**DRAFT**  
**EN 1993-4-2:2007**  
**prA1**

## Eurocode 3 - Design of steel structures - Part 4-2: Tanks

This draft amendment A1, if approved, will modify the European Standard EN 1993-4-2:2007. If this draft becomes an amendment, CEN members are bound to comply with the CEN/CENELEC Internal Regulations which stipulate the conditions for inclusion of this amendment into the relevant national standard without any alteration.

Figure 1.2 — Local coordinate systems for meridional and circumferential stiffeners".

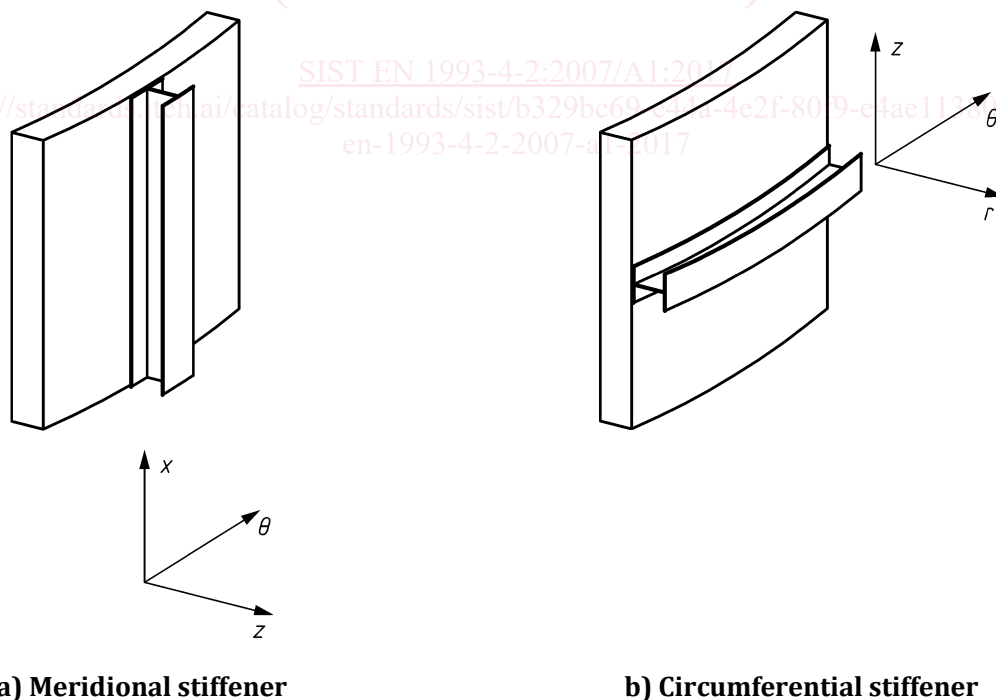
Replace Figure 1.3 with the following new Figure 1.2:
